INDESIT company

Model type:
MTB241

Commercial code:
F028992

0521123: SEALS FOR DOORS FOAMED AS ONE PIECE

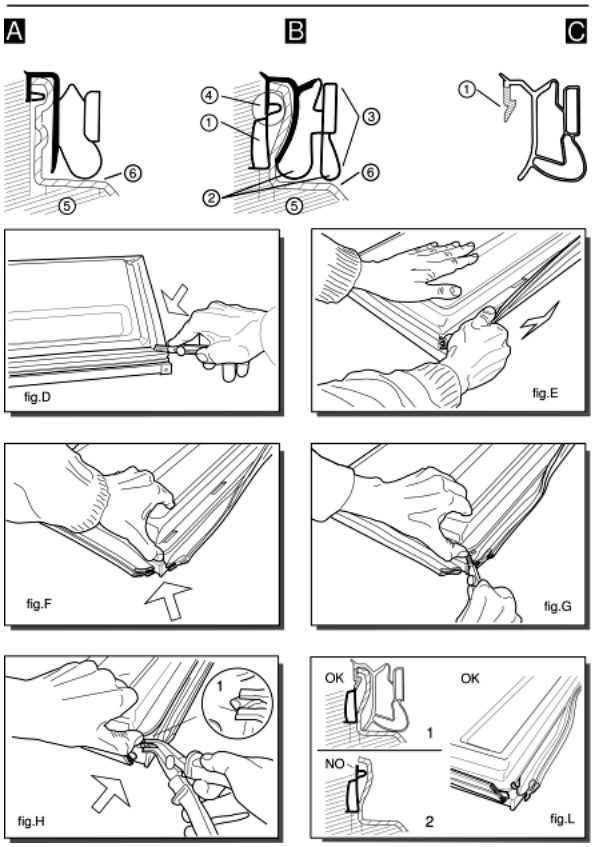
Various types of gaskets with different profile, as shown in figures (A) and (B), are used to fix the door (fig. A-5; B-5) and the inner door (fig. A-6; B-6) on the block foamed doors of combined freezers and refrigerators.
---Ilpea profile 245; 179; 412 (fig.A)
---Ilpea profile 287 (fig.B)
When replacing gaskets with profiles 245; 179; 412 these are fixed with screws (2 per corner) to the door.
Gaskets with profile 287 can not be used as spare parts but are designed to house the Ilpea type 900 gaskets (see figure C).
When replacing the gasket (287), once it is removed you will find a pocket (fig. B-1) between the door and inner door.
The rigid tooth (fig.C-1) of the gasket (900) is inserted inside between the pocket and the inner door, doing away with the need for screws.
Gasket with profile 287 is easy to identify since it has an exterior double edge (fig.B-2) which acts as a cushion when the door is closed.

To replace this gasket, follow these steps:
---Dismount the door and cut the four corners of the gasket along the joint (fig.D);
---lift the gasket and pull it carefully along its full length without tearing it (fig.E).
The purpose here is to detach the inner door slightly from the foam along the exterior edge for a depth equal to that of the gasket (fig.B-3);
---lift the corner of the inner door slightly, prising it up with your thumb (fig.F). Do not use a tool which might break the inner door;
---continue cutting the gasket inside the inner door for about 6 mm (fig.G);
---push in the tip of the pliers (type USAG N131) and pull outwards until you see the top edge of the pocket (fig. B-4) which is empty (fig.H-1);
---if you carry out this operation correctly (fig.L) you will be able to pull off the top edge of the pocket for the full length of the door.
If the gasket tears before the top edge (fig. L-2) you should repeat this operation from the other corner of the door.

---once the gasket (287), has been removed the space above the pocket (fig. L-1) can house the rigid tooth (fig. C-1) of the gasket 900.
When you fit this gasket ensure that it lies flush against the edge for the full length of the door.
If the rigid tooth is difficult to fit, eliminate any residues of foam between the door and the inner door in the gasket area.
fig.5131549A

n1025158: New central hinge for Ariston-55 2-door 240 litre refrigerators (Carinaro).

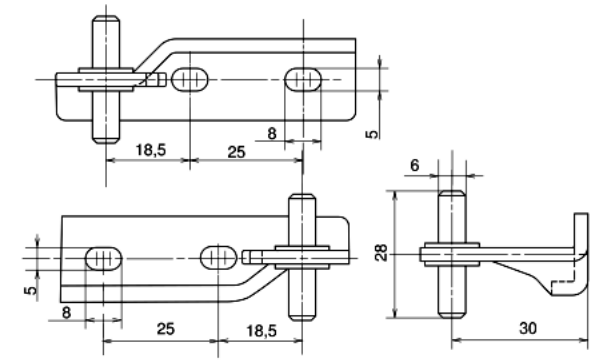
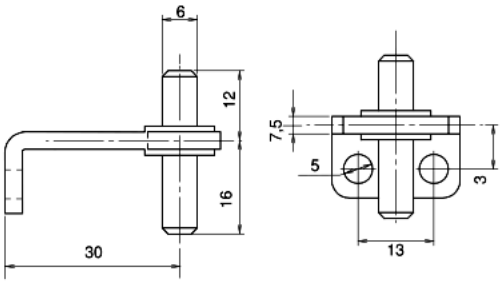
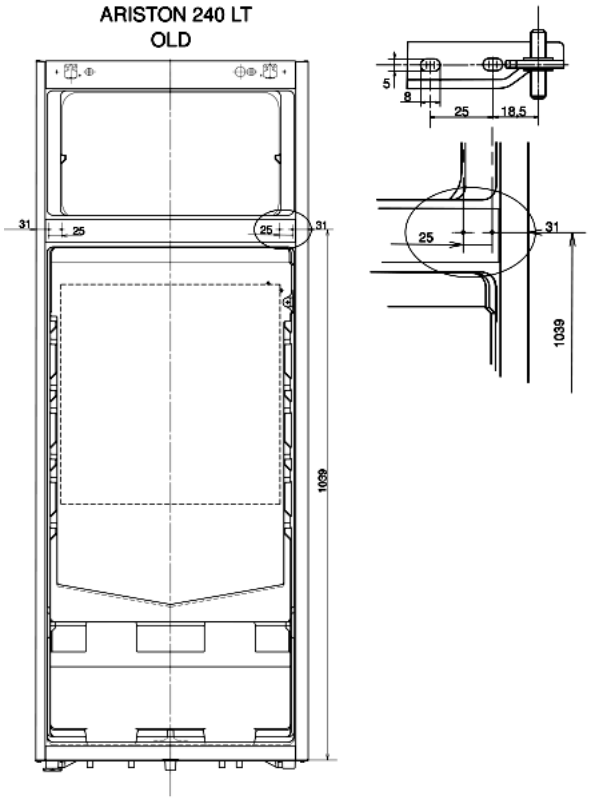
From serial no. 60123.0001, the Carinaro factory has modified the body of 240 litre refrigerators by introducing a new central hinge (see figure N1025058 Fig.1) attached to the side panel.
This hinge is still reversible but cannot be fitted on premodification models where the hinge was attached to the central trim of the refrigerator body (see Figure N1025058fig2).
When changing the door opening from right to left, the new hinge does not need to be inverted like the previous one, just moved to the left side.
To secure it, a hole must be made on the left side of the refrigerator body (see figure N1025058fig3).

Parts affected

141794 - POLAR WHITE CENTRAL HINGE (CARINARO)
142756 - POLAR WHITE CENTRAL HINGE (MANISA)
142756 - CHROME-PLATED CENTRAL HINGE

Parts replaced

053838 - CHROME-PLATED CENTRAL HINGE
053478 - WHITE CENTRAL HINGE
114624 - POLAR WHITE CENTRAL HINGE

OLD 053838 - 053478 - 114624

NEW 141794 - 142760 - 142756
